Report to Development Permit Panel

To: Development Permit Panel **Date:** February 19, 2020
From: Wayne Craig **File:** DP 17-766824
 Director of Development
Re: **Application by Matthew Cheng Architect Inc. for a Development Permit at**
8100 No. 5 Road

DP 17-766824 – RELIGIOUS ASSEMBLY BUILDING

SITE PLAN

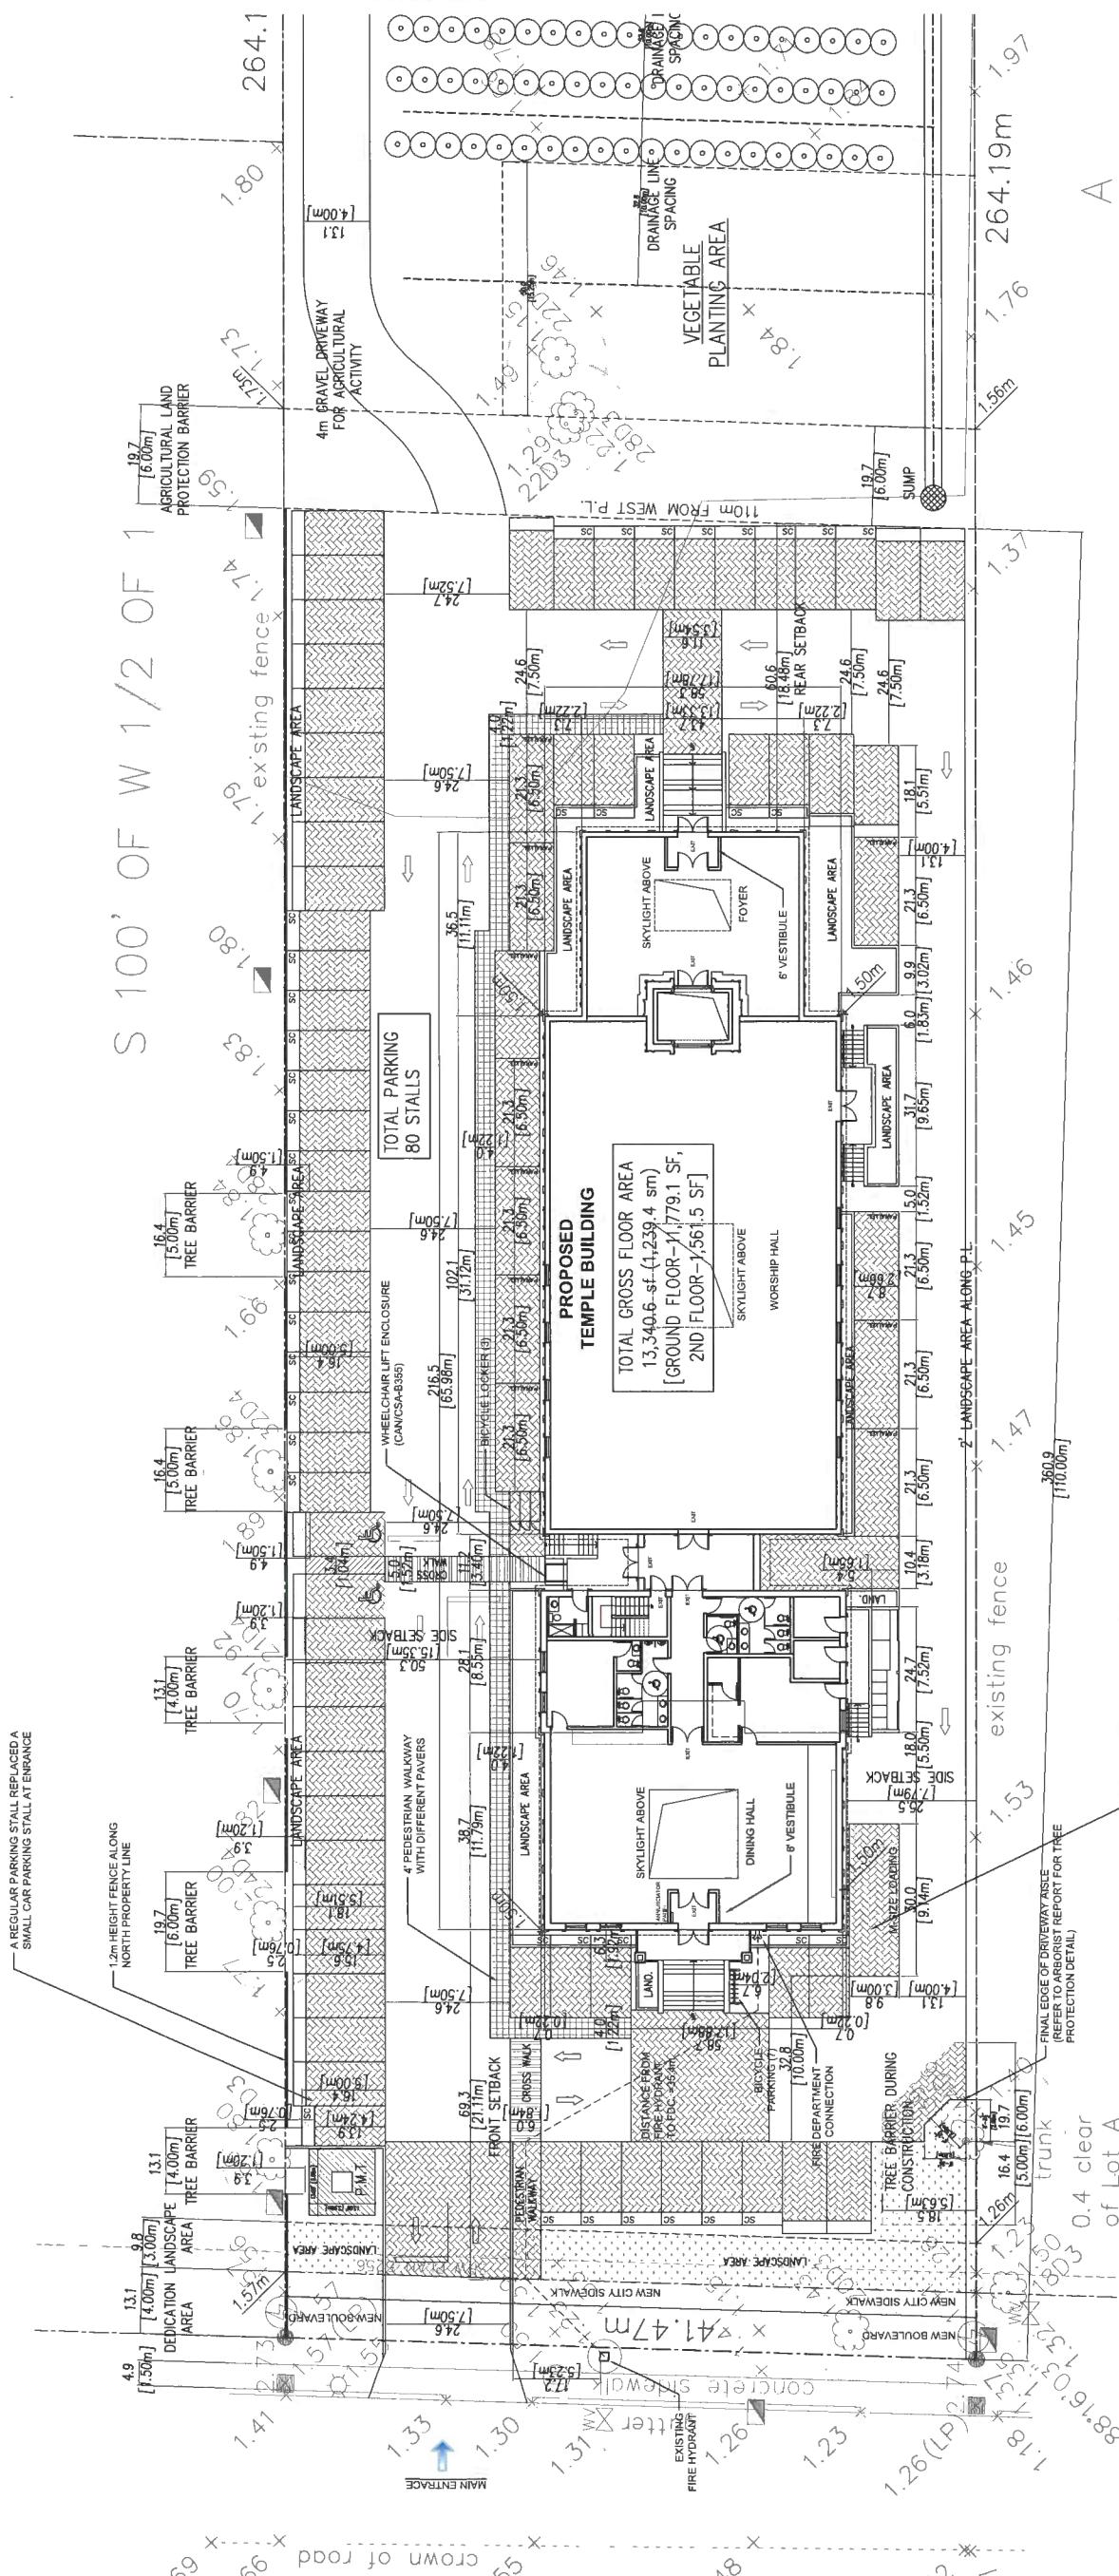
- consider installing a pedestrian pathway along the internal drive aisle to define pedestrian circulation areas throughout the site;

- support the comment to delineate on-site pedestrian circulation areas to avoid pedestrian conflict with vehicular circulation on the site;

- the design rationale for the proposed Hindu temple, e.g. symmetrical design, is not well executed in outdoor spaces fronting the building entrance from No. 5 Road and at the rear entrance to the building; would include a centered outdoor space in front of the building stairs; consider design development to align with the applicant's stated design rationale/principles;

- note the use of significant amount of space for parking stalls around the site; consider incorporating additional landscaping at the parking stalls near the front entrance to the building to celebrate the entry to the site;

- concerned about pedestrian safety in the internal drive aisle; consider introducing measures to enhance pedestrian safety on the site;

- concerned about pedestrian safety on the internal drive aisle, especially for pedestrians entering the site from No. 5 Road and accessing the temple through the foyer at the back of the building; consider installing a pedestrian walkway along the internal drive aisle on the south side to enhance pedestrian safety;

- support Panel comments/queries regarding loading, parking and lighting for the site as they will all have an impact on pedestrian safety on the site; applicant should have provided information regarding the truck turning radius on the site; note that site corners appear tight;

- review the location of the parking space between the loading bay and garbage and recycling area; and

- anticipated high volume of potential pedestrian and vehicular traffic from the site entry off No. 5 Road to the back entrance of the building is not reflected in the site plan and will give rise to pedestrian safety issues; applicant should address the Panel's concerns regarding pedestrian safety on the site.

4' walkway around the building with different pavers provided to define pedestrian and vehicle traffic, refer to D01, 02.

4' walkway around the building with different pavers provided to define pedestrian and vehicle traffic, refer to D01, 02.

The main entrance to the temple has been relocated to the north side of the property in order to provide a gathering area in front of the temple, refer to D01, 02.

The main entrance to the temple has been relocated to the north side of the property in order to provide a gathering area in front of the temple, refer to D01, 02.

4' walkway around the building with different pavers provided to define pedestrian and vehicle traffic, refer to D01, 02.

4' walkway around the building with different pavers provided to define pedestrian and vehicle traffic, refer to D01, 02.

4' walkway around the building with different pavers provided to define pedestrian and vehicle traffic; lighting fixture provided on landscape design dwg. Regarding the truck turning radius issue, truck should go from the single way driveway on the south side and park at the loading area in order to avoid turning radius issue, refer to D01, 02.

Parallel parking behind loading area has been deleted in order to have more maneuvering area for truck. A regular parking stall replaced a small car stall near the entrance. The number of parking stalls is 79 and still fulfilled the requirement of parking bylaw refer to D01,02

4' walkway around the building with different pavers provided to define pedestrian and vehicle traffic; main entrance relocated to the north side, refer to D01, 02.

GROUND FLOOR PLAN

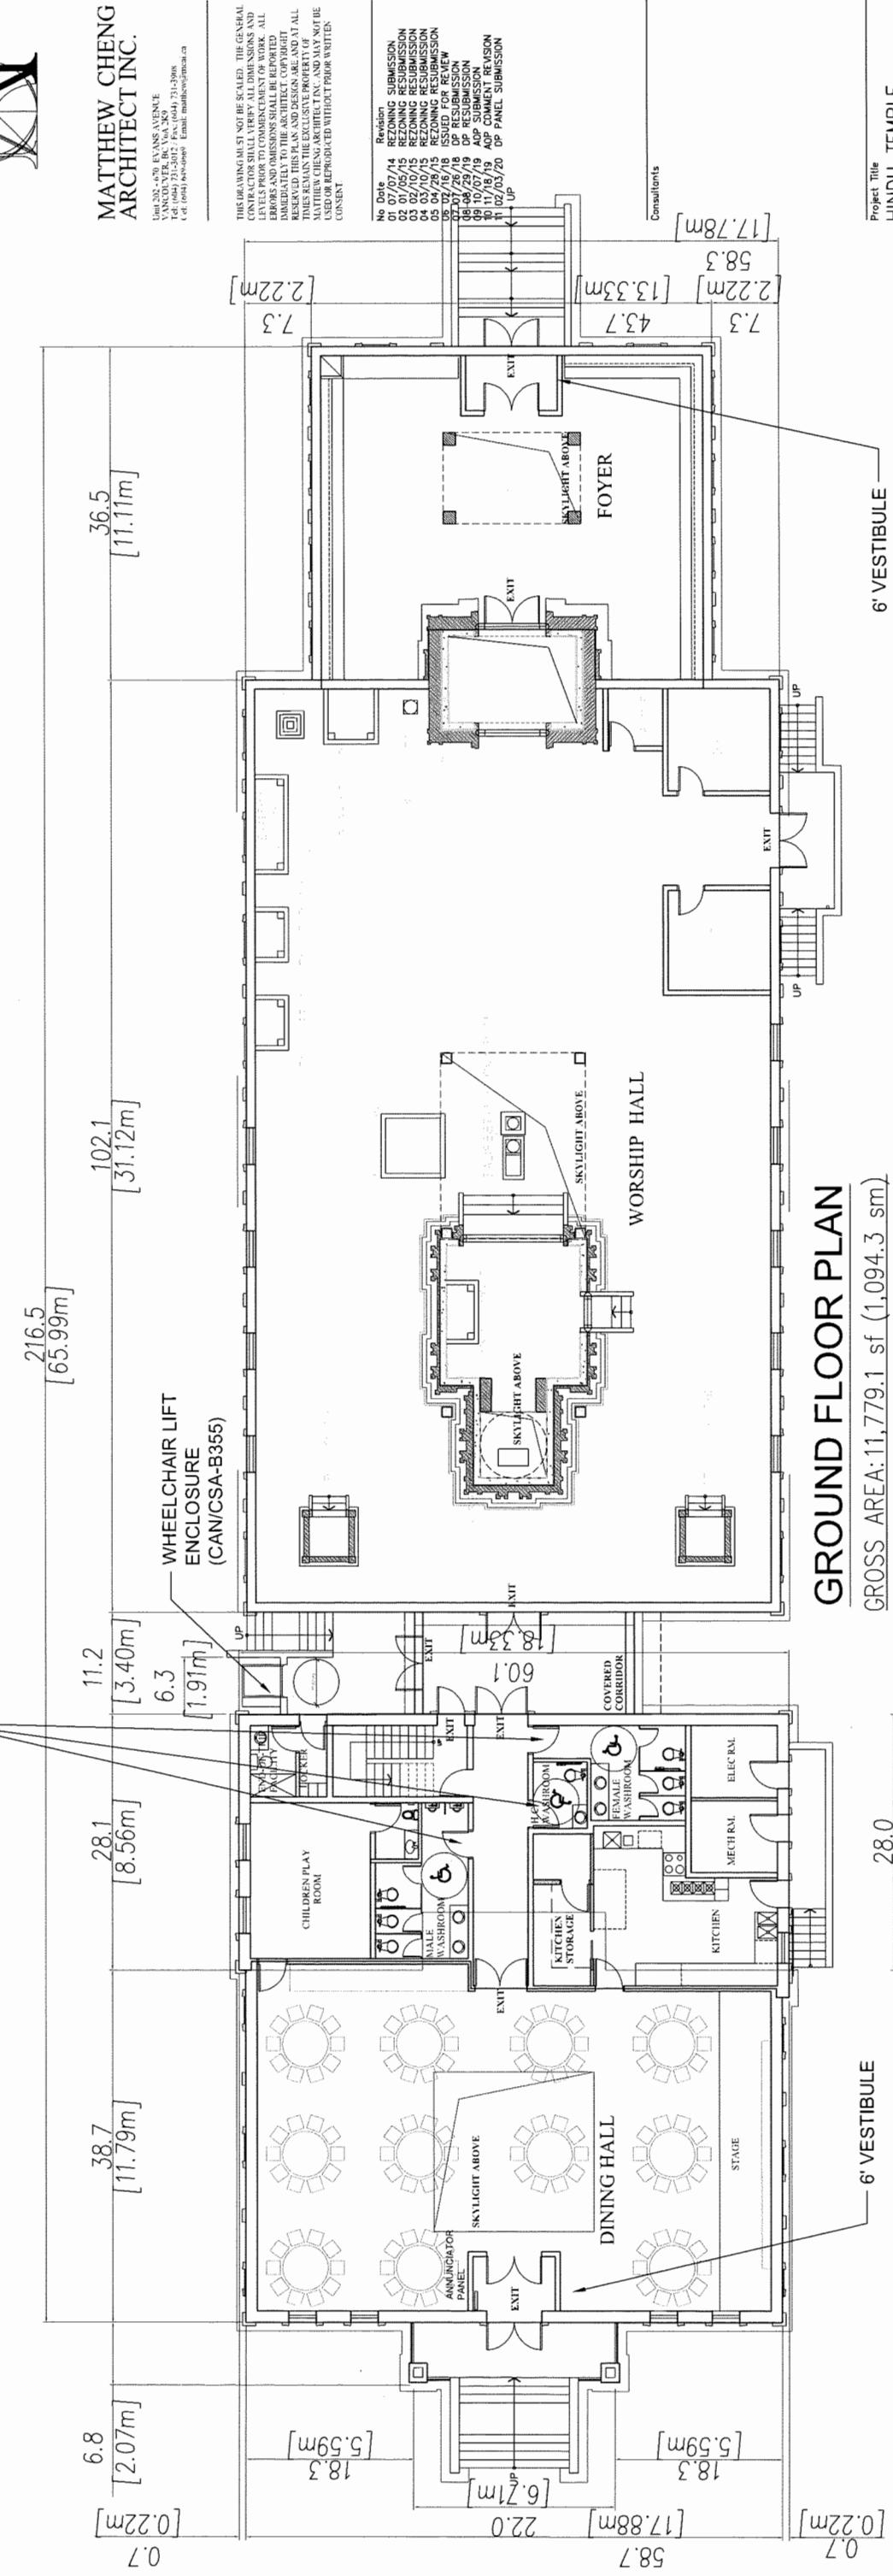
- consider installing an outward swinging door in lieu of the proposed inward swinging door for the accessible washroom to enhance its accessibility;

- the applicant is advised to provide vestibules at the building entrances to comply with BC Building Code requirements;

Automatic door opener will be provided for H/C accessibility, refer to D03.

Vestibules provided for dining hall and foyer, refer to D03.

- AUTOMATIC DOOR OPENER
PROVIDED FOR H/C
ACCESSIBILITY

Sheet Title ROOF PLAN

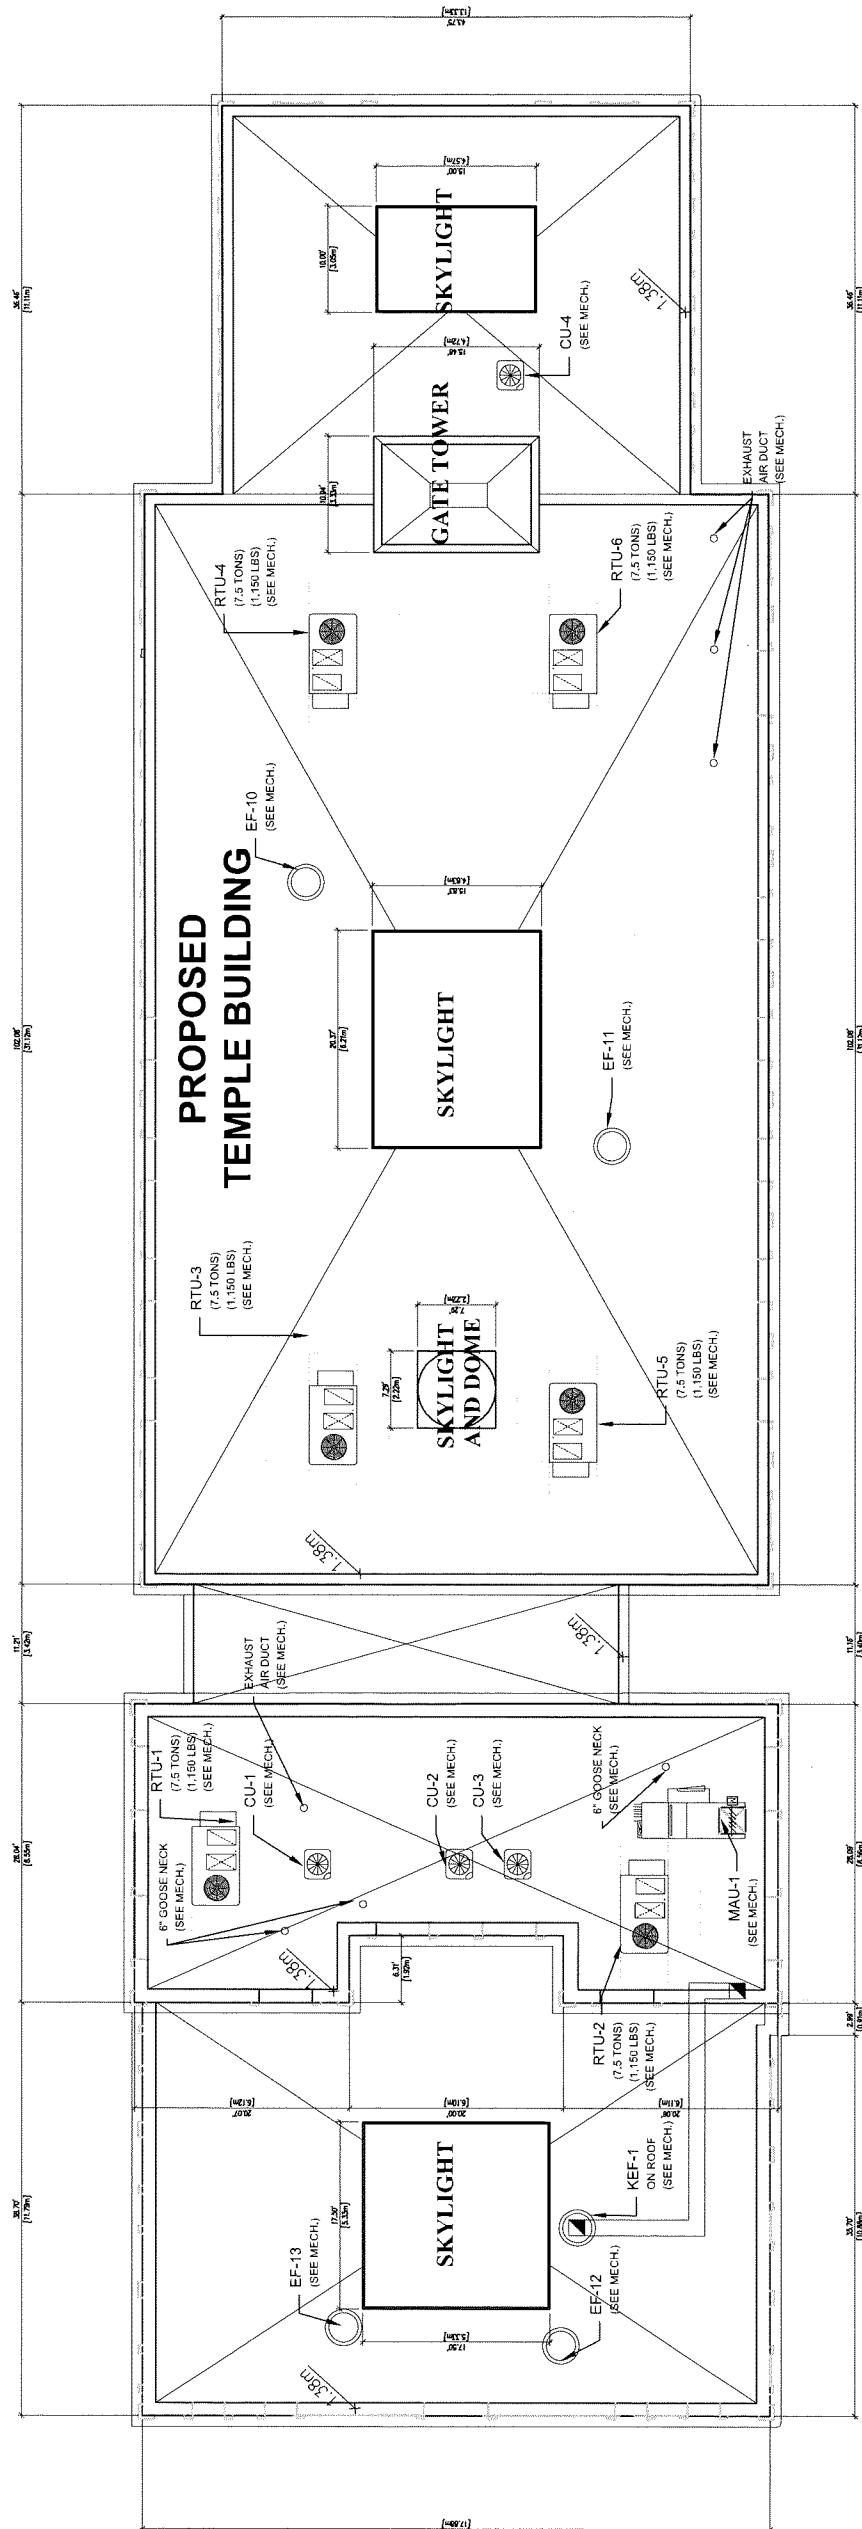
- appreciate the applicant for showing mechanical units and the parapet wall screening on the rooftop in the roof plan to hide the mechanical units; however, consider installing fencing around these units consistent with the building's architectural features to provide additional screening;

**ALL MECHANICAL FACILITY
WILL BE SCREENED BY THE
PARAPET WALL ON THE
ROOF TOP.**
